TITLE OF INVENTION: Wine Case

Notice of Allowability For A Design Application	Application No. 29/895,014	Applicant(s) Alexander, Barry	
	Examiner AMANDA K BIRDWELL	Art Unit 2931	AIA (FITF) Status Yes

RESPONSE TO OFFICE ACTION

FIG. 8

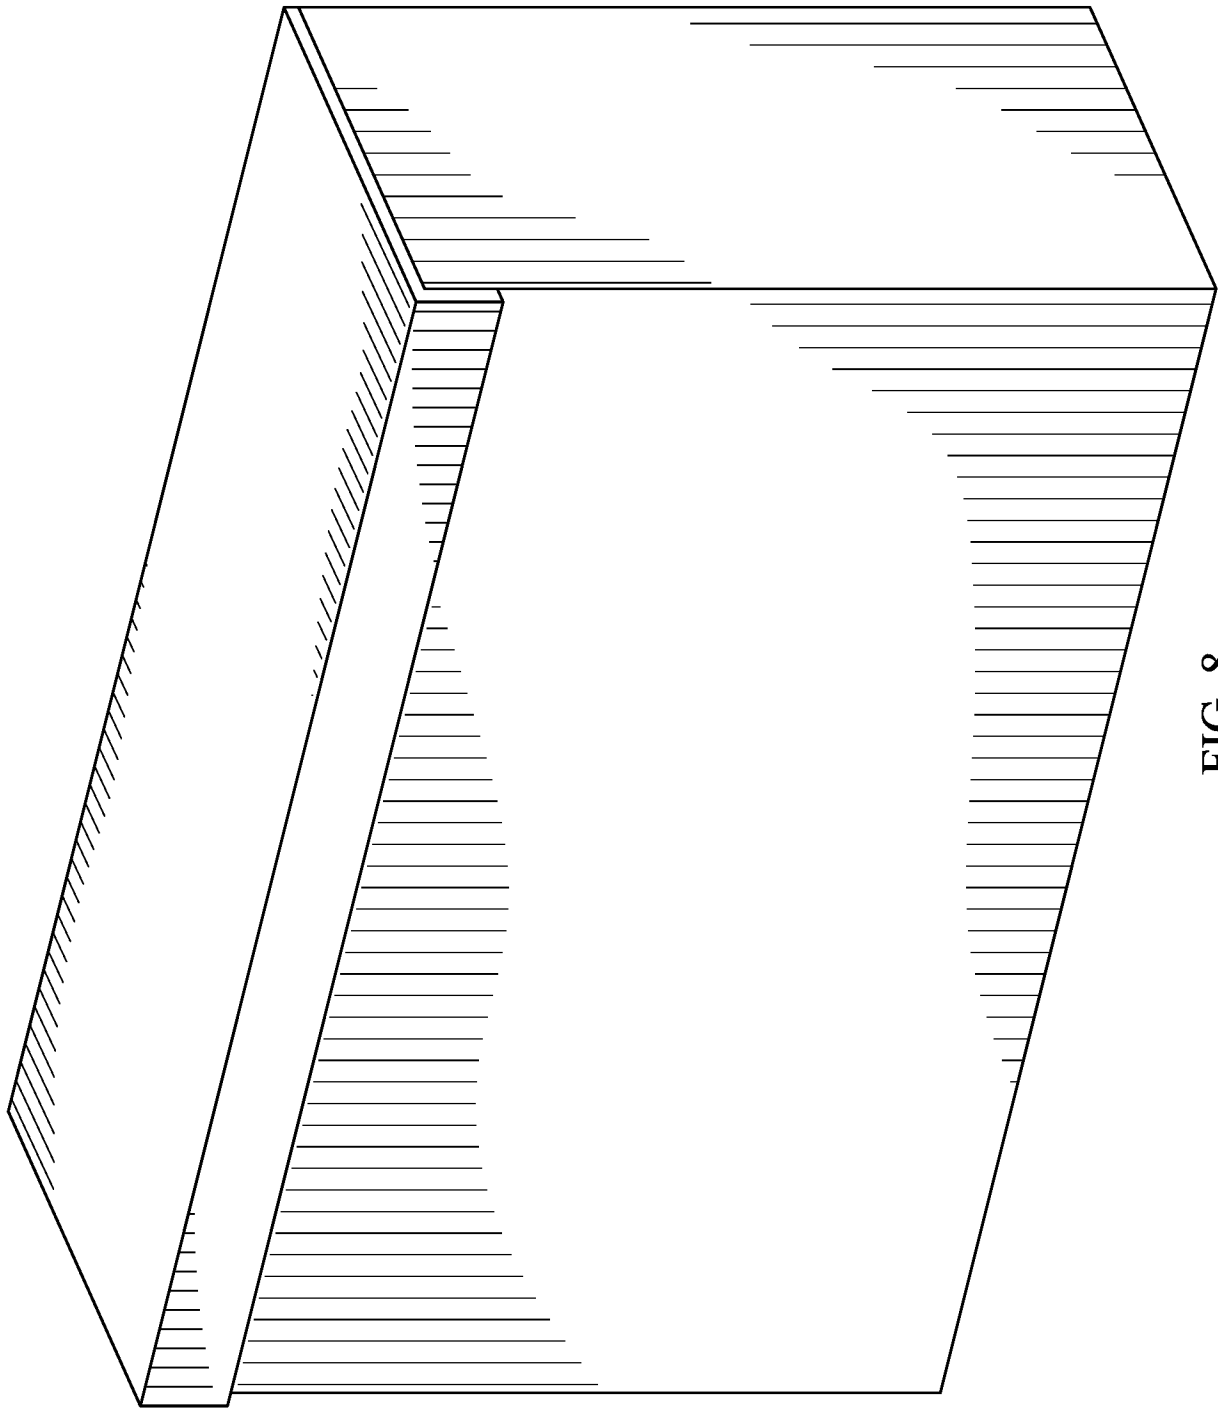
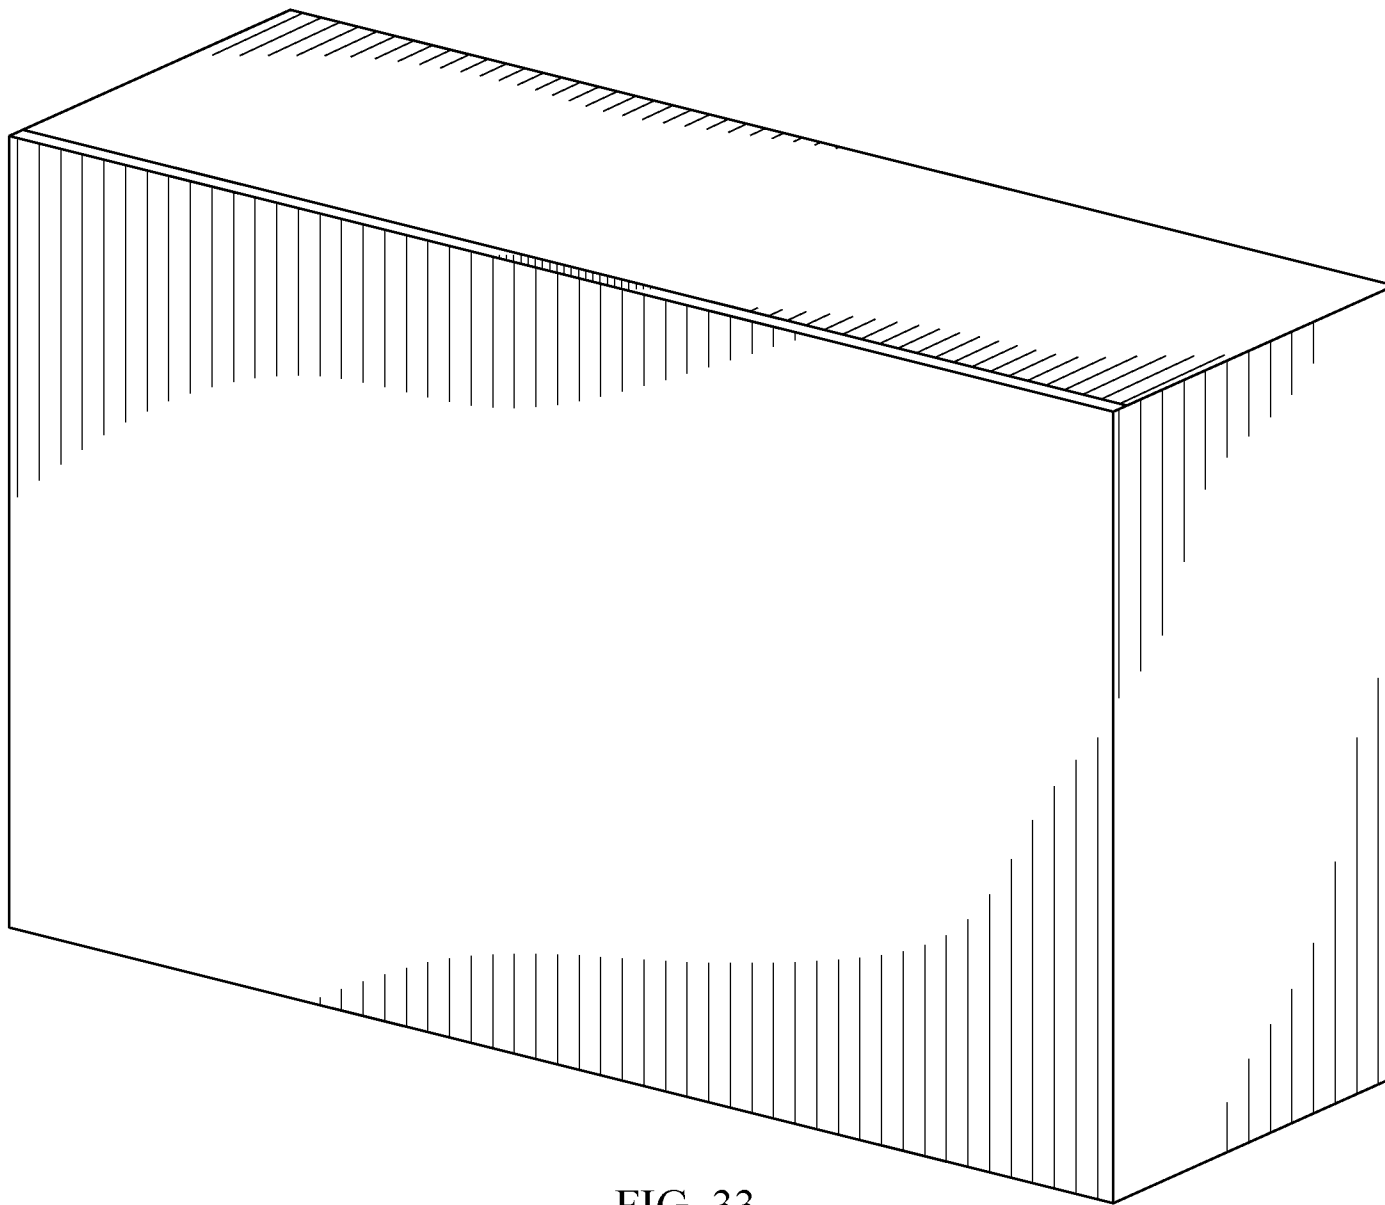
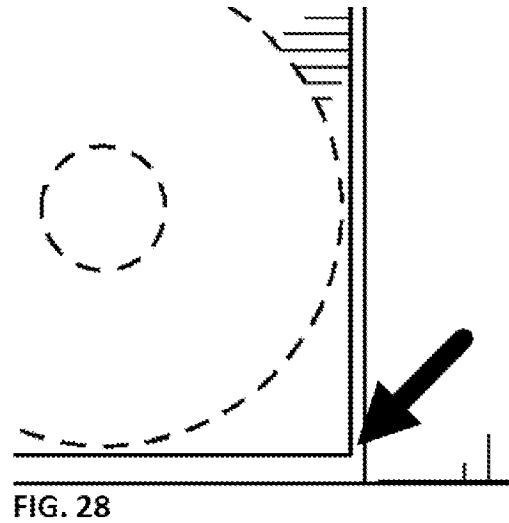
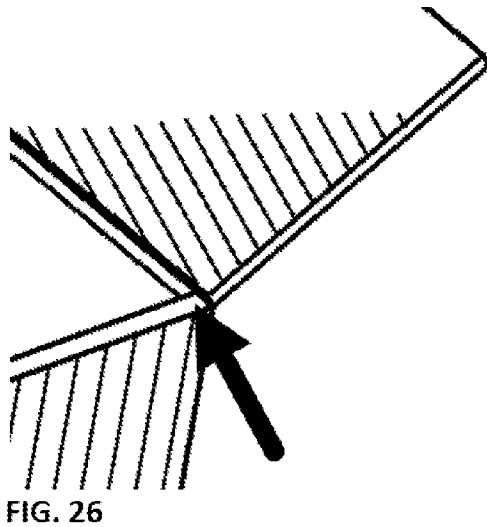
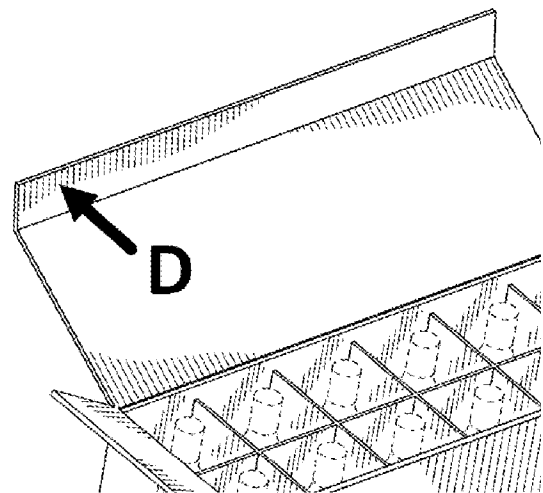
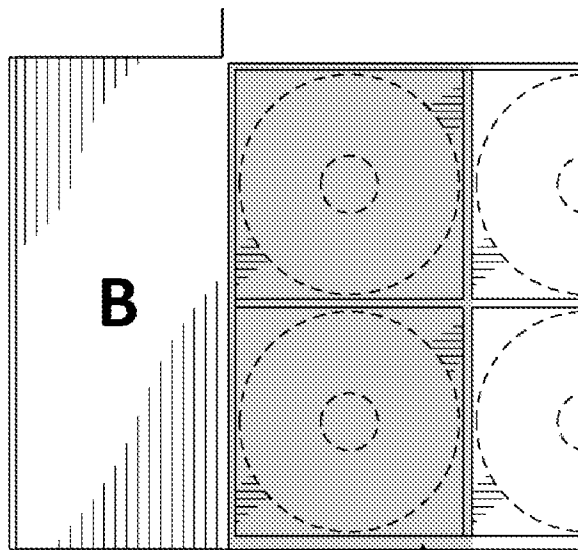
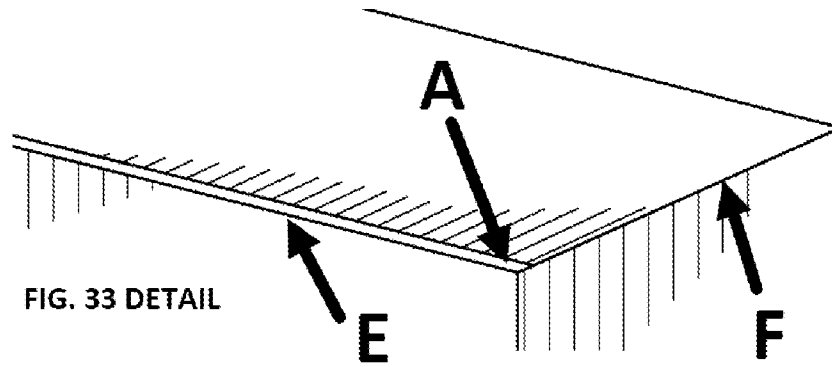
FIG. 33 shows the appearance of the wine box inconsistently with the other drawings.

Specifically, Fig. 33 shows the case tightly sealed, with the smaller portion of the top flap understood to be inserted into the case (Arrow A). The manner of closure shown in Fig. 33 is not achievable when considering the other views. The area marked in grey in Fig. 28 below indicates the approximate placement of the side flaps when folded into the case. As they are an equal width as the case, these side flaps would overlap the front wall of the case (Arrow C). This leaves no space for the smaller portion of the top flap to be inserted into the case, making the tightly closed wine case as shown in Fig. 33 impossible. These side flaps, which run the entire width of the crate, do not even appear to be present in Fig. 33 (Arrow E).

Additionally, given the appreciable thickness of the crate's flaps, the outside edge of the top flap should be visible when the wine crate is closed (Arrow F). See diagrams below.

Figure 8 (formerly Figure 33) has been amended to depict the small portion of the top as outside the box when it is closed, and to show the right edge of the top flap. flap in the same position as the top flap in Figure 3. This amendment is supported by original Figures 26, 28 and 30.
